**Response to Submissions - Application MP 10_0135 Capital II Wind Farm -
Modification 2 (Blade Length)**

The following report is prepared in response to submissions received regarding the Proponent's application (MP 10_0135) to modify the Capital II Wind Farm Project Approval to increase the wind turbine blade length by 6m.

PHOTOMONTAGE 1A PROPOSED 57m BLADE & 100m TOWER OVERALL HEIGHT OF 157m (BASED ON APPROVED WTG)

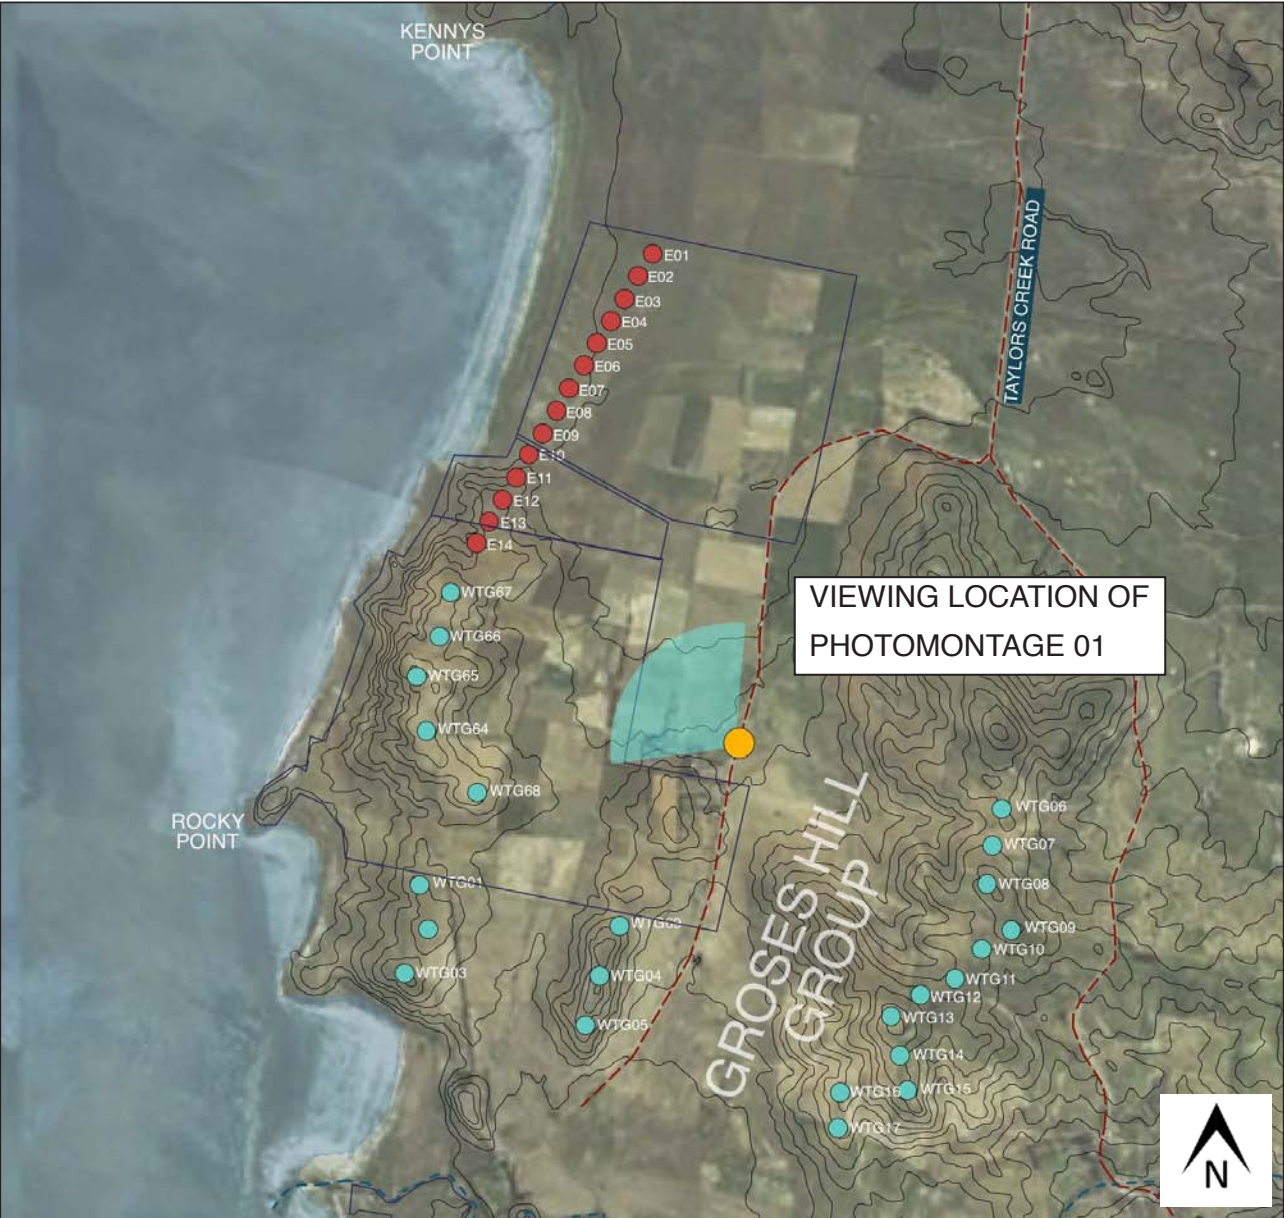
- Photomontage 01A (refer to Sheet 1) provides an indicative photomontage illustrating the proposed northern group of WTGs with the approved 57 metre blade length (114 metre diameter) and a 100 metre tower (overall blade tip height of 157 metres).

- Photomontage 01B (refer to Sheet 1) provides an indicative photomontage illustrating the proposed northern group WTGs with the modified 63 metre blade length (126 metre diameter) and a 94 metre tower (overall blade tip height 157 metres).

It is evident from the photomontages that the landscape character of the viewpoint does not vary between the approved and modified sizes. Any variation in height is difficult to discern, particularly in the context of the broader view as depicted in Photomontages 01A, 01B, 02A and 02B.

PHOTOMONTAGE 1C (ZOOMED AND CROPPED FROM PHOTOMONTAGE 01A) PROPOSED 57m BLADE & 100m TOWER OVERALL HEIGHT OF 157m (BASED ON APPROVED WTG)

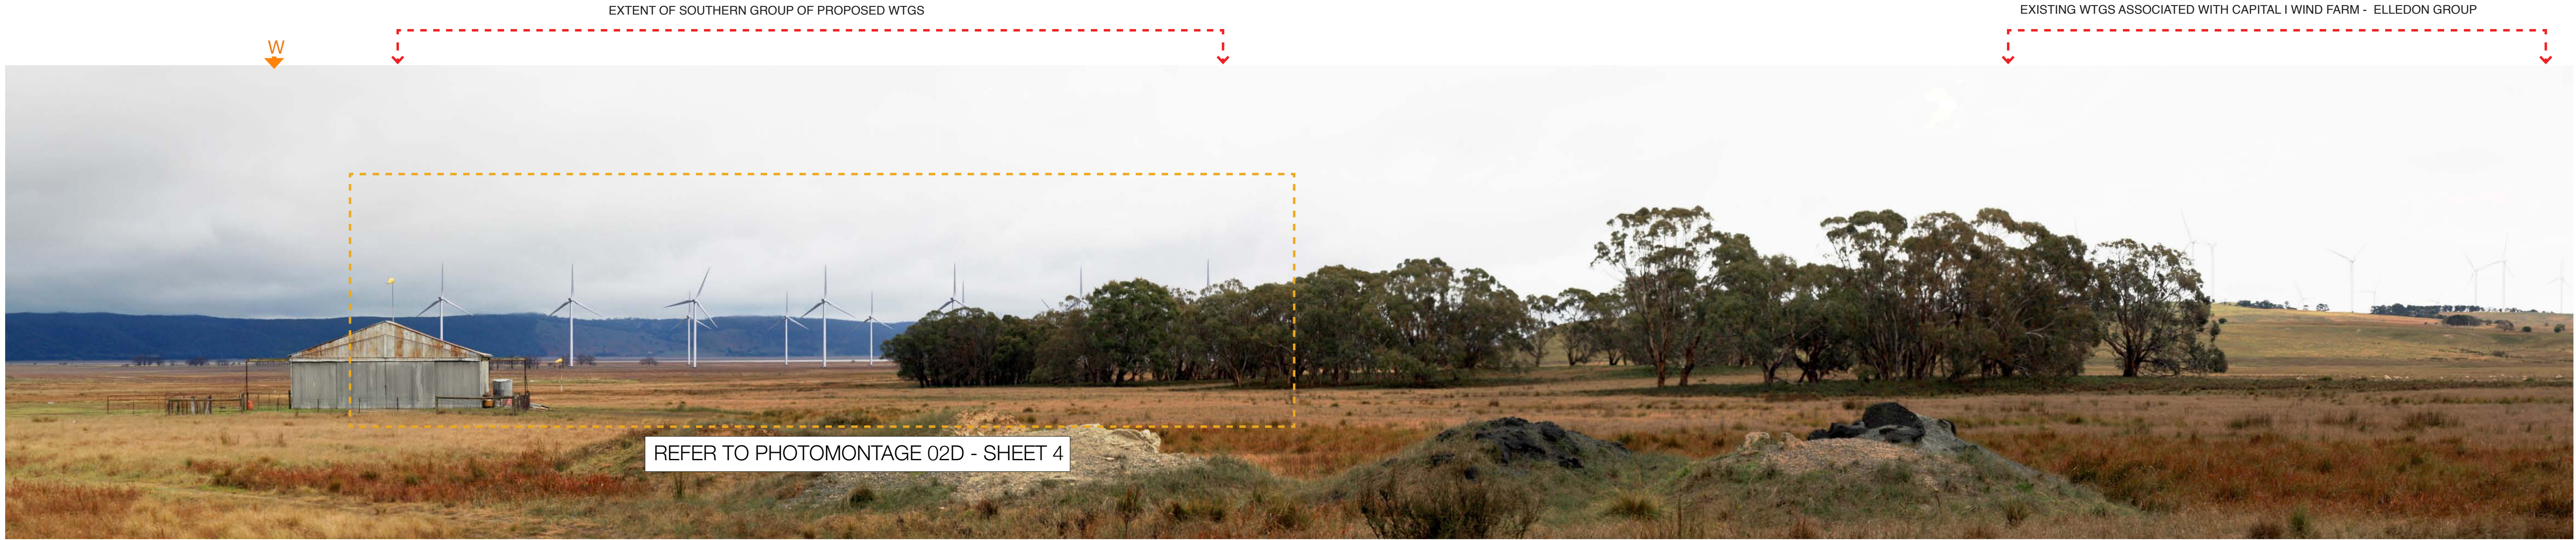
- Due to the viewing distance Sheet 2 and Sheet 4 provide zoomed and cropped images of photomontages 01 and 02.

PHOTOMONTAGE 2A PROPOSED 57m BLADE & 100m TOWER OVERALL HEIGHT OF 157m (BASED ON APPROVED WTG)

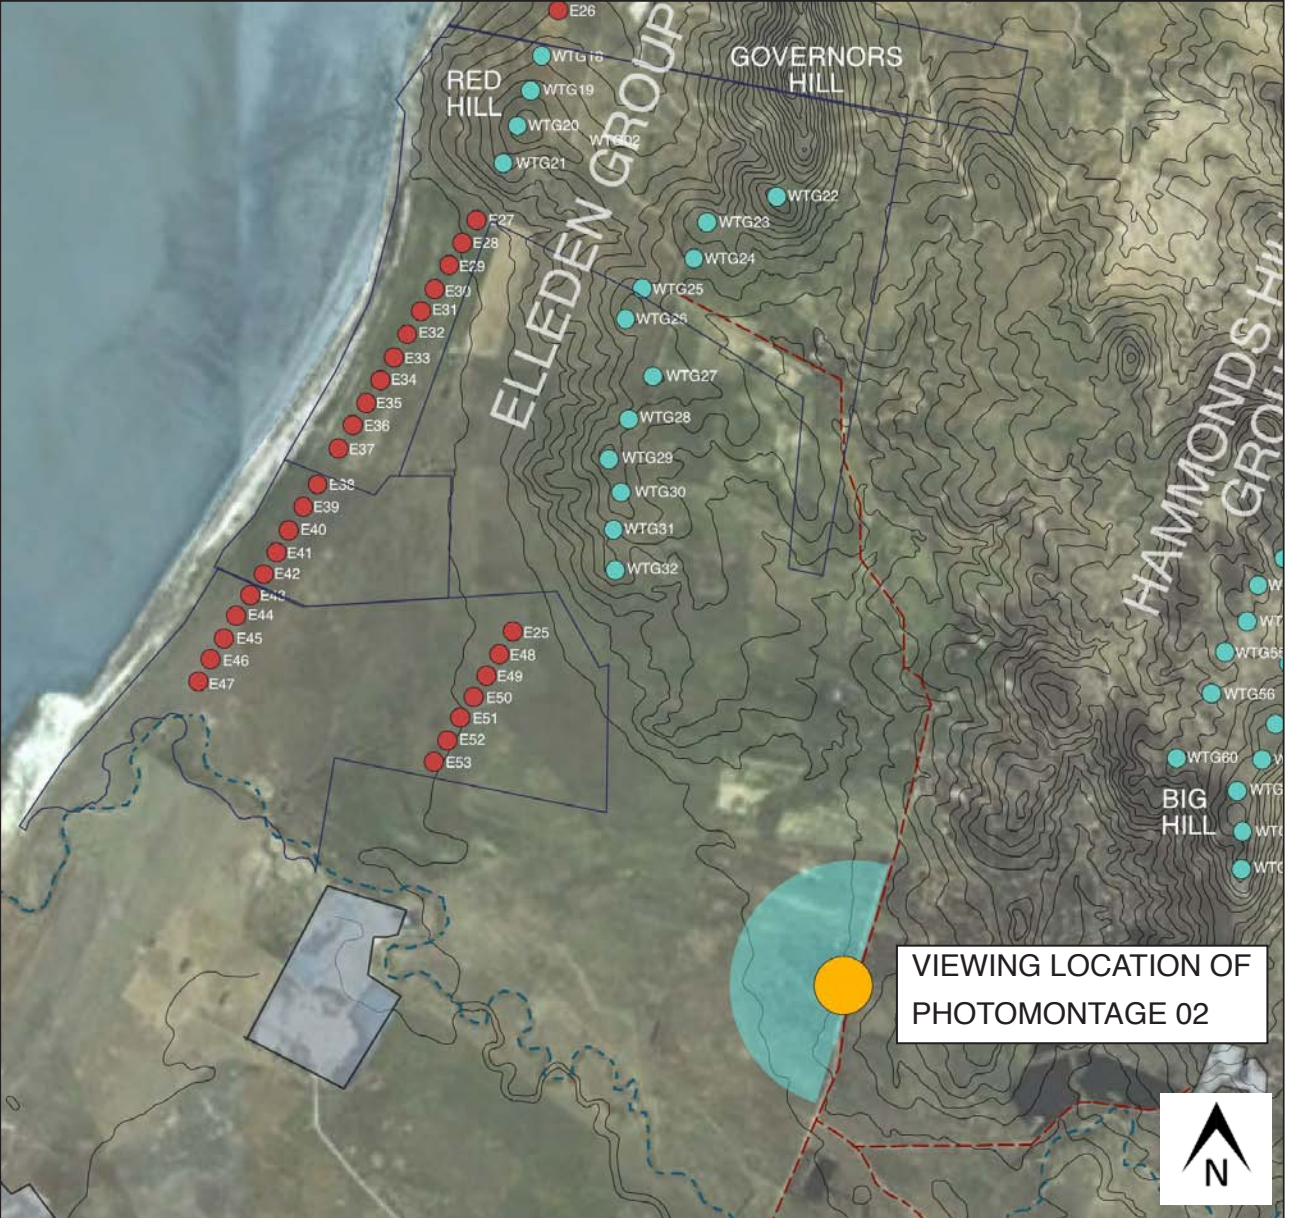
- Photomontage 02A (refer to Sheet 3) provides an indicative photomontage illustrating the proposed southern group of WTGs with the approved 57 metre blade length (114 metre diameter) and a 100 metre tower (overall blade tip height of 157 metres).

- Photomontage 02B (refer to Sheet 3) provides an indicative photomontage illustrating the proposed southern group of WTGs with the modified 63 metre blade length (126 metre diameter) and a 94 metre tower (overall blade tip height 157 metres).
